Re: Results of Particulate Matter Air Dispersion Modeling Analyses for Permitted Modifications to the Nos. 3 and 4 MAP Plant and the Proposed Modifications for the No. 5 DAP Plant for Cargill Fertilizer, Inc.,
Permit AC29-196763

Subject: Construction Permit Application AC29-196763
No. 5 DAP Plant Expansion

Re: Permit Application AC 29-196763, No. 5 DAP Plant Expansion

Subject: Construction Permit Application AC29-196763
No. 5 DAP Plant Expansion

FIGURE A-6

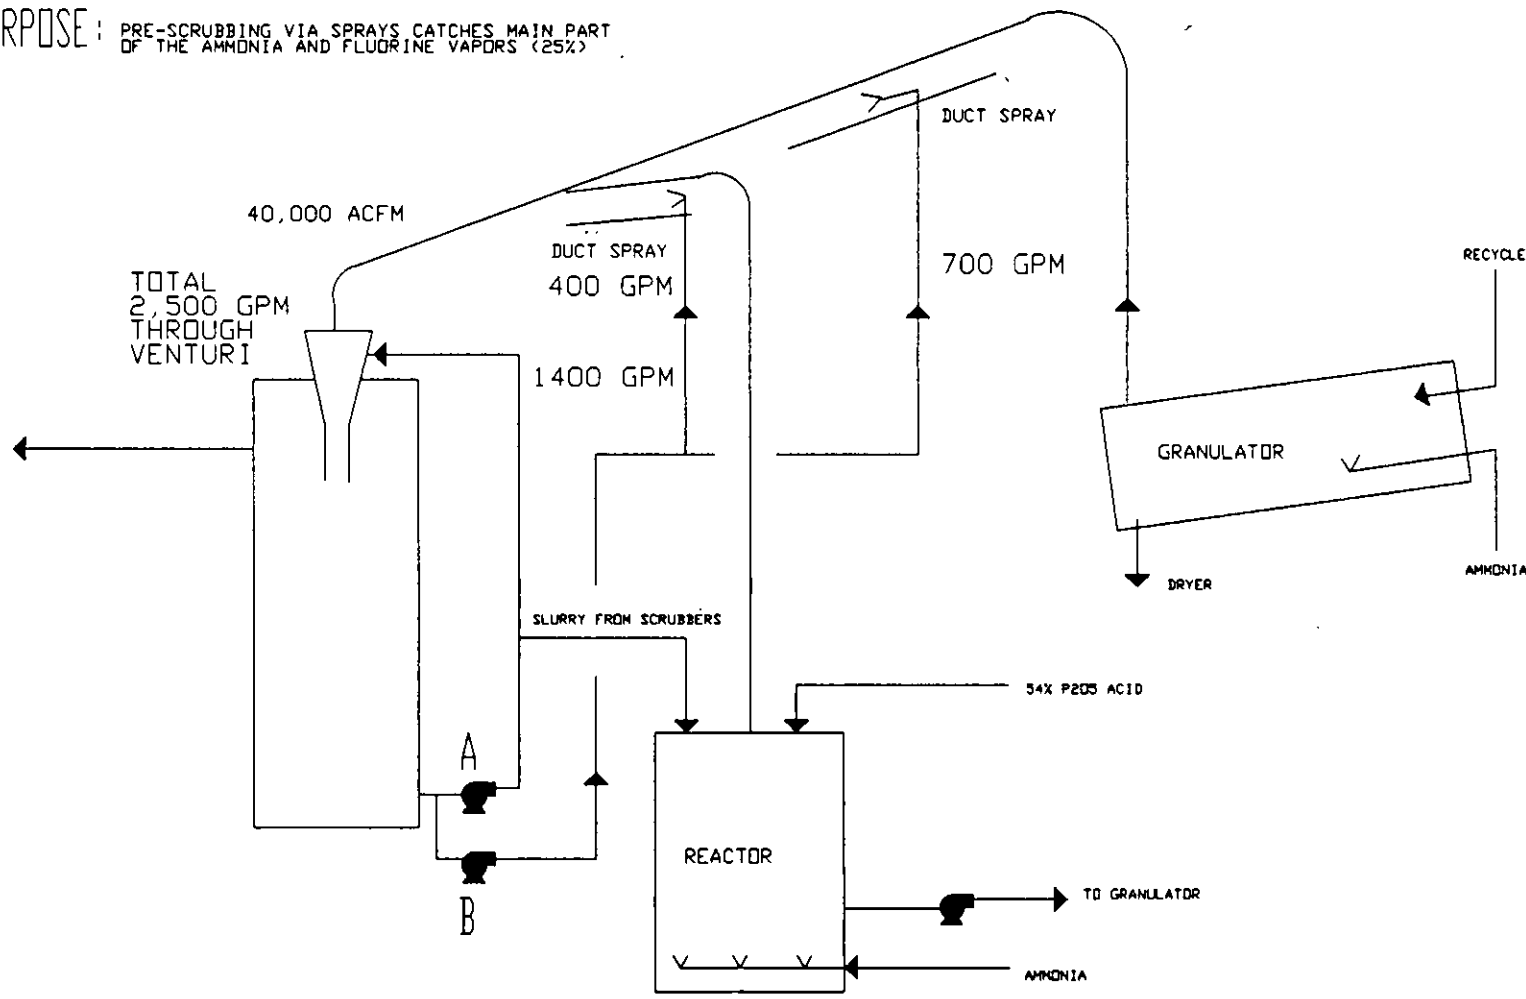
- 5) Describe the additional ammonia recovery "system" mentioned on page A-2.
- 6) Identify the sources making up the "previous actual" emissions footnoted on Table A-2 and show all shutdown dates. Also show dates (or years) for which previous actuals are based.

5. Additional ammonia recovery will be accomplished by installation of a new pump to circulate reactor granulator

primary scrubber liquid at approximately 700 gpm across the granulator duct and about 400 gpm across the reactor duct.

The scrubber liquid has P/N mole ratio of approximately 0.6 and will catch about 30% of the ammonia and fluorine reducing loading to the reactor/granulator venturi scrubber. A sketch of this system is attached as Figure A-6.
